Access Compliance Report

Public Rights-of-Way

(Curb Ramps)

Intersection ID: 10032791	Main Street: N_WENDOVER_RD	Cross Street: N/A	Location: SW
ADA ID: 343ACC68ECA8	Ramp Type: PerpDiag	Initial Pass/Fail: Fail	Overall Compliance: No
		Severity Score: 12.5

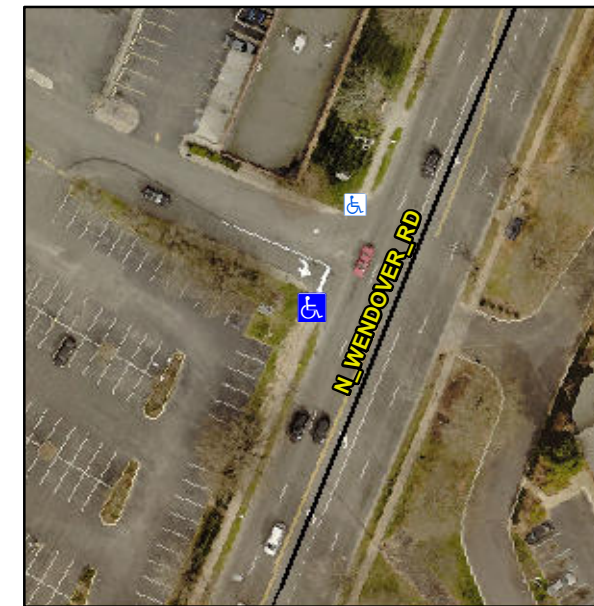
Not Found, R304.2.2

Compliance	Description	Data	Compliance	Description	Data
N/A	Ramp Length (in)	68.0	No	Ramp Slope (%)	8.6
Yes	Ramp Width (in)	48.0	Yes	Ramp XSlope (%)	0.2
N/A	Flare Type LT	N/A	N/A	Flare Type RT	N/A
N/A	Flare Slope LT (%)	N/A	N/A	Flare Slope RT (%)	N/A
N/A	Flare Traversable LT?	N/A	N/A	Flare Traversable RT?	N/A
N/A	Landing Length (in)	N/A	N/A	DWS Provided?	N/A
N/A	Landing Width (in)	N/A	N/A	DWS Contrast?	N/A
N/A	Landing Slope (%)	N/A	N/A	DWS Length (in)	N/A
N/A	Landing X Slope (%)	N/A	N/A	DWS Full Width?	N/A
N/A	Landing Curb? (Y/N)	N/A	N/A	DWS Offset (in)	N/A
N/A	Shared Landing?	N/A			
N/A	Gutter Ponding?	N/A	N/A	Gutter Slope (%)	N/A
N/A	Gutter Lip Ht (in)	N/A	N/A	Gutter X Slope (%)	N/A
N/A	Painted X Walk1?	No	N/A	Painted X Walk2?	No
	X Walk 1 Direction	To NE		X Walk 2 Direction	To NW
N/A	X Walk 1 Width (in)	N/A	N/A	X Walk 2 Width (in)	N/A
	X Walk 1 Slope (%)	5.3		X Walk 2 Slope (%)	0.4
	X Walk 1 X Slope (%)	1.2		X Walk 2 X Slope (%)	3.8

Remove & Replace Curb Ramp With Two New Directional Ramps or Equivalent.
